# V2500 Propulsion System - Nacelle **SERVICE BULLETIN**

NACELLE - EXHAUST - COMMON NOZZLE ASSEMBLY, STRUT ATTACH BOLTS -  
REPLACEMENT OF

January 22, 1999

**V2500-NAC-78-0165**

CNA Strut Attach Bolt Replacement  
Figure 1 (Sheet 1)

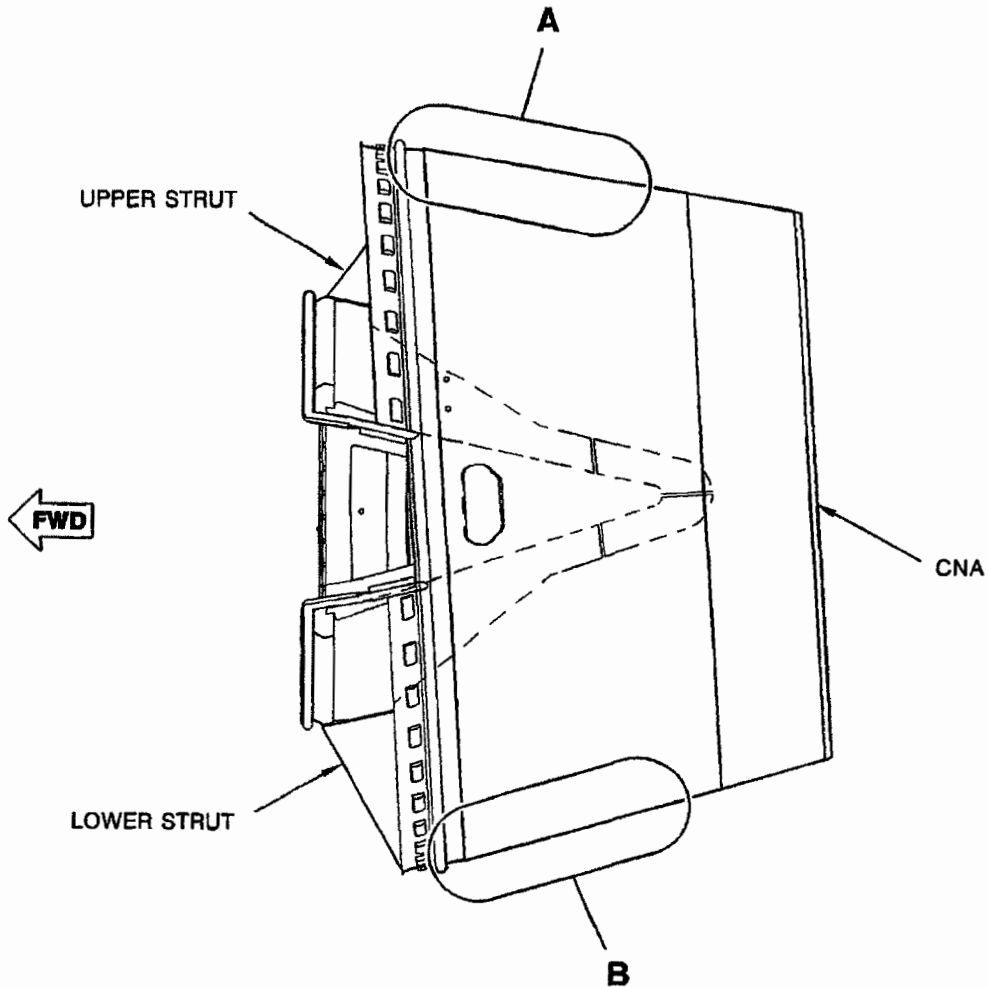
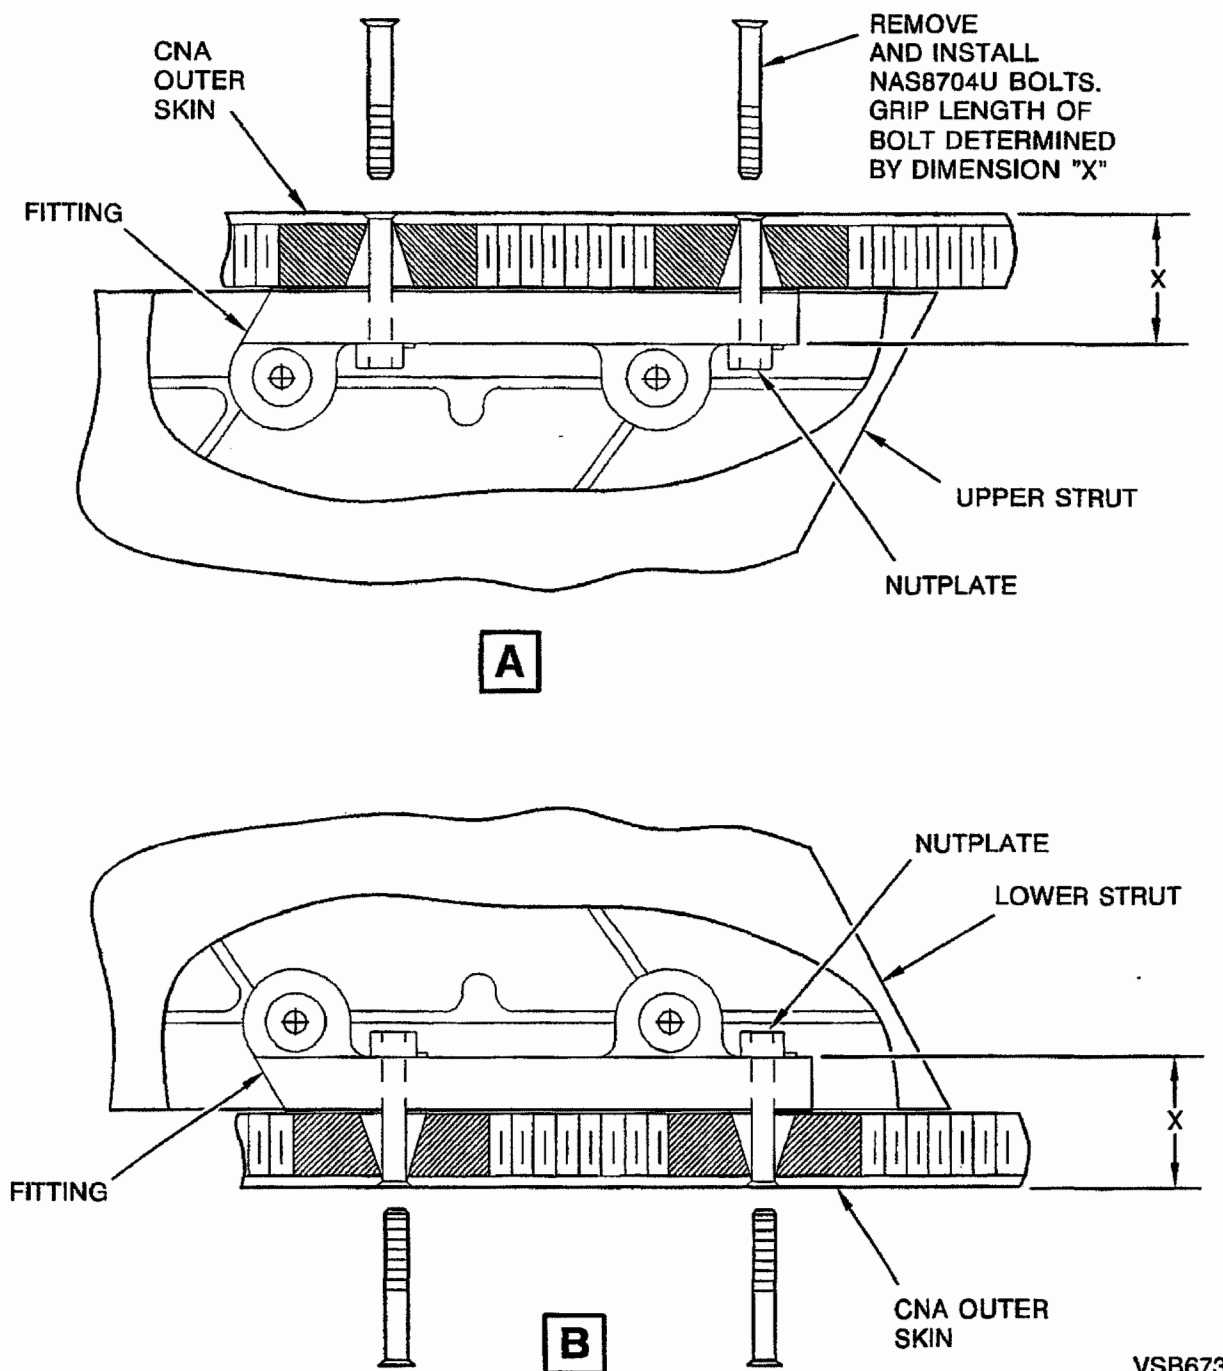
**Operators have found loose CNA struts and damage to the CNA inner and outer skins caused by the strut attach bolts.**

**The CNA strut attach bolts can be too long and interfere with an internal part of the struts and/or the shanks of the bolts can interfere with and damage the strut nutplates. This can result in a loose strut even though the attach bolts are properly tightened.**

- (1) Remove the four NAS8704U23 or NAS8704U24 CNA strut attach bolts from the top and bottom of the CNA. Refer to Figure 1.
- (2) Find the proper length CNA strut attach bolt(s).

- (a) Install one NAS8704U22 bolt in each of the struts. Torque the bolts to 50 to 60 inlb (5,7 to 6,8 Nm). Refer to Figure 1.
  - (b) Measure the distance (dimension X) from the surface of the CNA outer skin to the nutplate at each of the attach bolt locations that do not have bolts installed. Refer to Figure 1.

- 1 If the distance is 1.348 to 1.394 inch (34.24 to 35.41mm), use a NAS8704U22 bolt.
    - 2 If the distance is 1.395 to 1.478 inch (35.43 to 37.54 mm), use a NAS8704U23 bolt.

- (c) Remove the bolts installed in step 2(a).
  - (d) Repeat steps (2)(a) through (2)(c) for the two remaining strut attach bolt locations.
- (3) Apply anaerobic compound sealant (Loctite 242) (CoMat 04-008) or Loctite 272 to the threads of the four bolts chosen in step (2). Refer to the manufacturer's instructions.

- (4) Install the four CNA strut attach bolts. Torque the bolts to 50 to 60 inlb (5,7 to 6,8 Nm).
